WATER QUALITY MEMORANDUM

Utah Coal Regulatory Program

RE: 2009 Third Quarter Water Monitoring, Canyon Fuel Company, LLC, Skyline Mine, C/007/0005, Task ID #3387

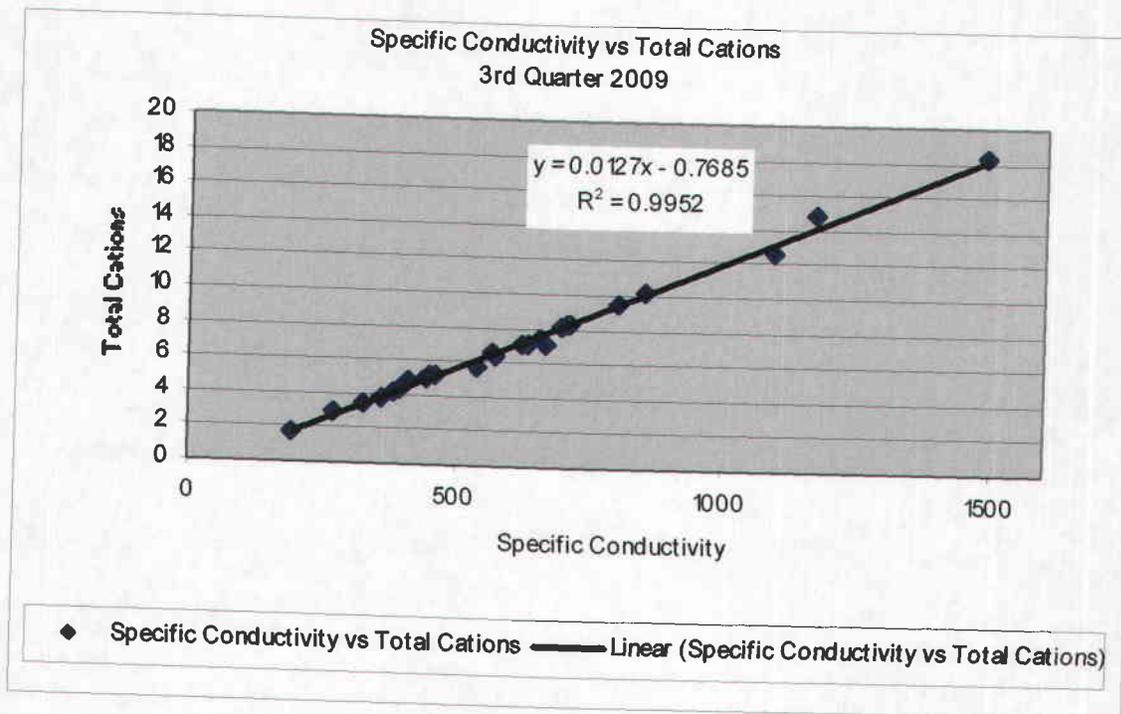
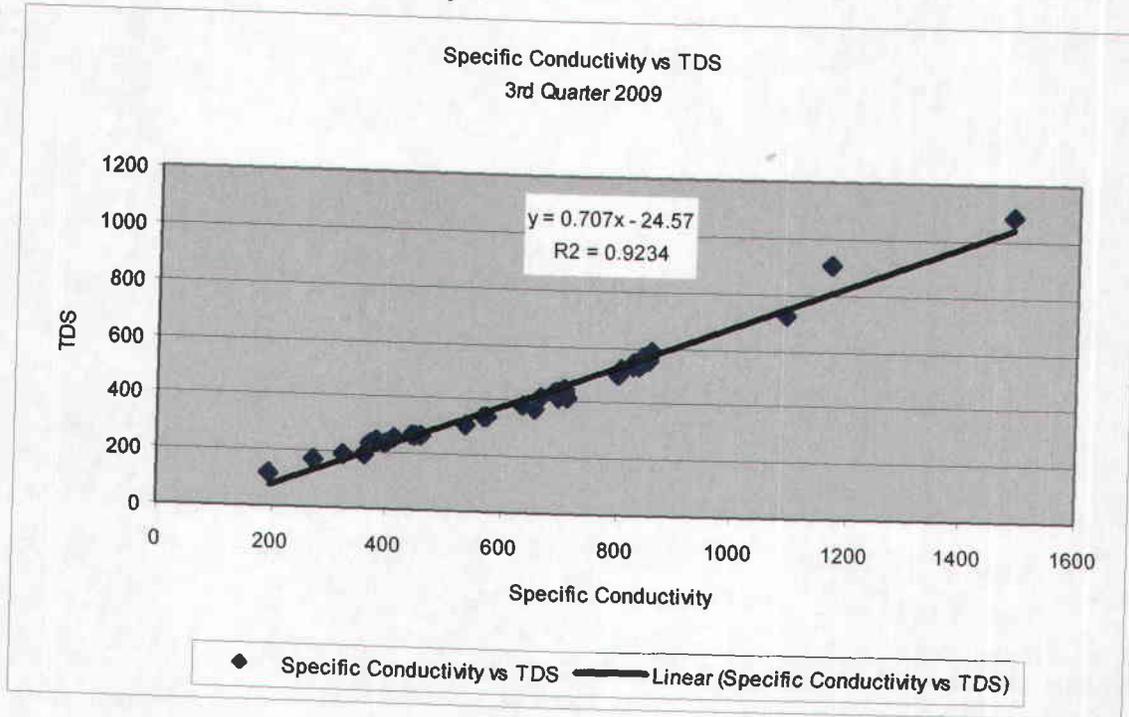
- TDS/Conductivity
 - Out of 39 samples for which both field specific conductivity and TDS were determined, 38 have TDS/Conductivity ratios between 0.55 and 0.76, and the ratio at 92-91-03 is 0.77. The linear trendline has a slope of 0.71 (see chart).
 - The 25 samples for which both field specific conductivity and total cations were determined have a Conductivity/Cations ratio of 0.87 to 1.26%, with an average value of 1.12%; this ratio should be close to 1%.
 - These two Reliability Check results are close to the expected values. The same checks done in previous quarters did not match expected

○ **Mg/(Ca + Mg) ratio**

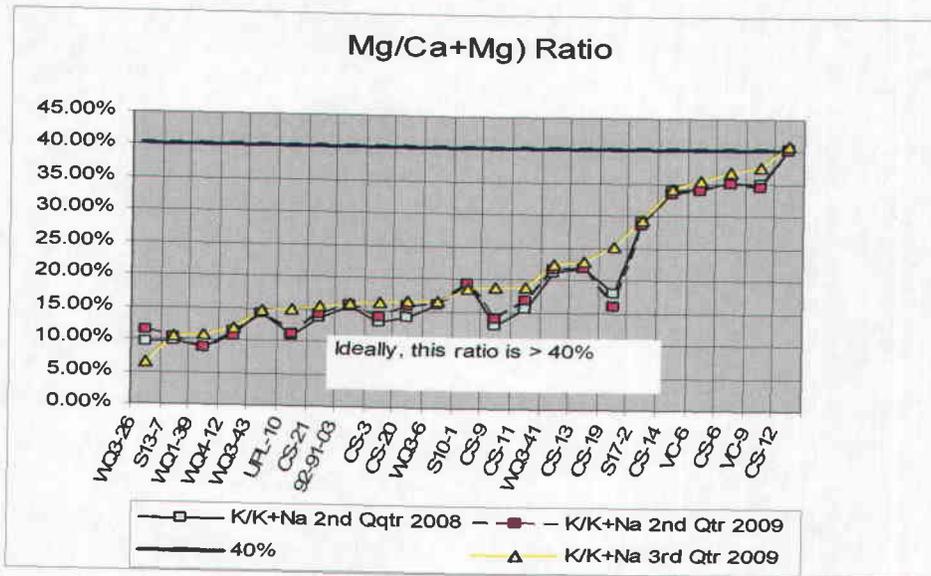
- Ideally the Mg/(Ca + Mg) ratio is < 40%.
- Of the 25 3rd Qtr 2009 samples, only CS-12 has a ratio > 40%.
- At CS-12, the ratio is 41%; CS-12 seems to consistently have the highest ratio (see chart – 23 of 25 sites).

○ **Ca/(Ca + SO4) ratio**

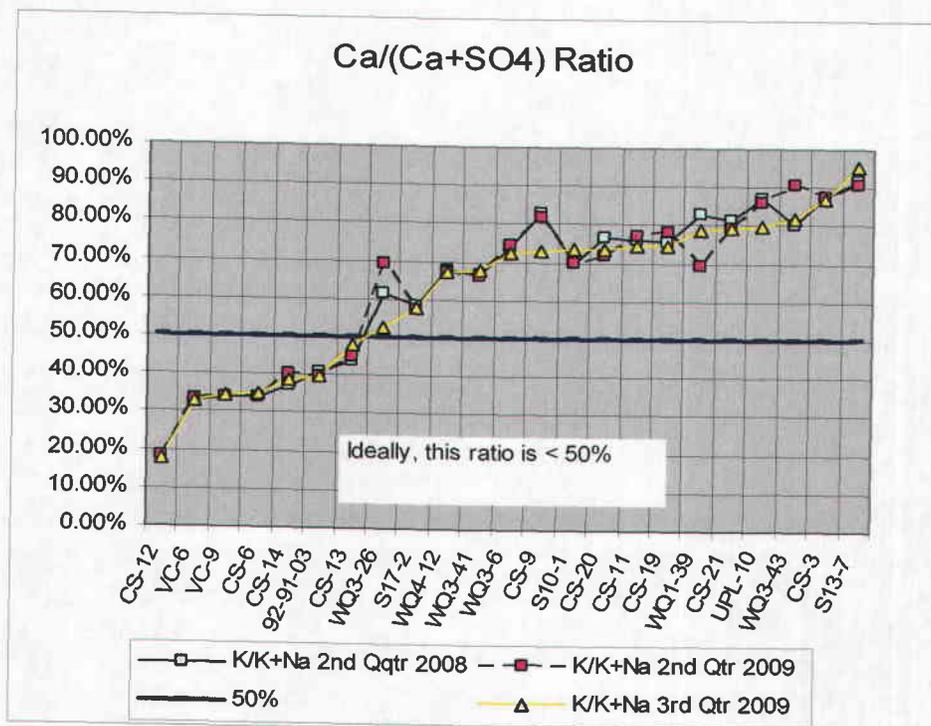
- Ideally the Ca/(Ca + SO4) ratio is < 50%
- Only 8 of the 25 3rd Qtr 2009 samples have a Ca/(Ca + SO4) ratio < 50%.
- This relationship appears to be consistent over time (see chart – 23 of 25 sites).

○ **K/(K+ Na) ratio**

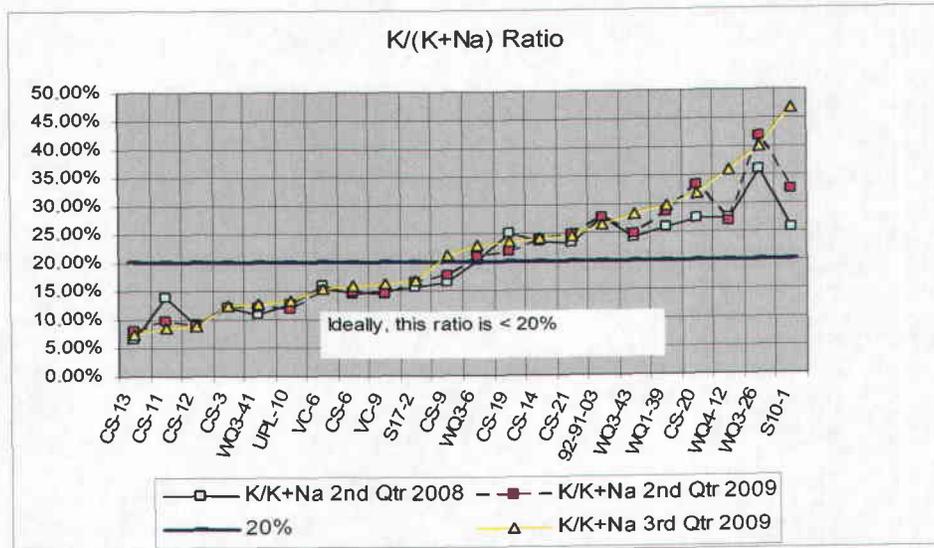
- The K/(K+ Na) ratio should be < 20%.
- This ratio is > 20% for 14 of the 25 3rd Qtr 2009 samples.
- At the remaining sites, the ratio ranges from 7 to 17%.
- This relationship appears to be consistent over time (see chart – 22 of 25 sites).

○ **Na/(Na + Cl) ratio**

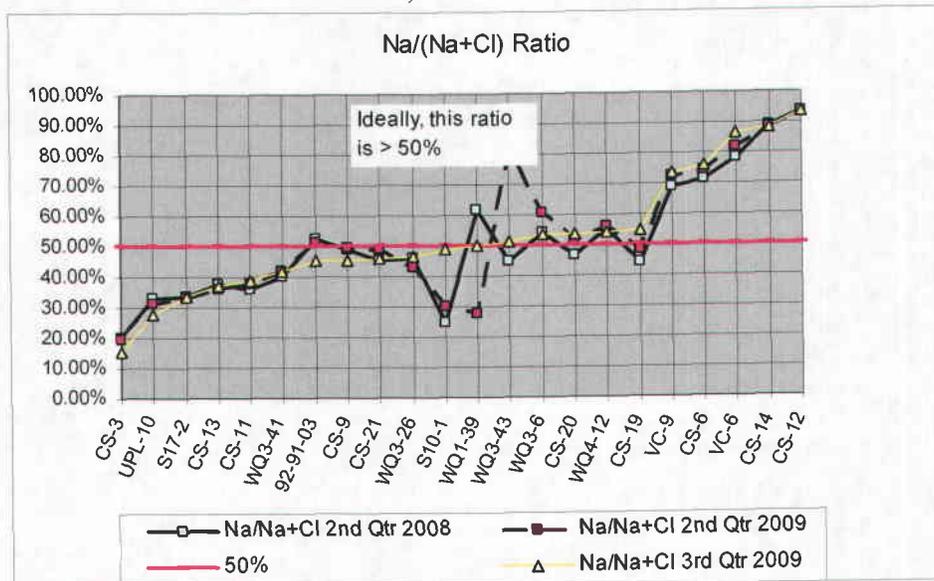
- The Na/(Na + Cl) ratio should be > 50%.
- For 13 of 25 3rd Qtr 2009 samples it is < 50%.
- The ratio is 50% to 93% at the remaining sites.
- This relationship appears to be consistent over time (see chart – 22 of 25 sites).
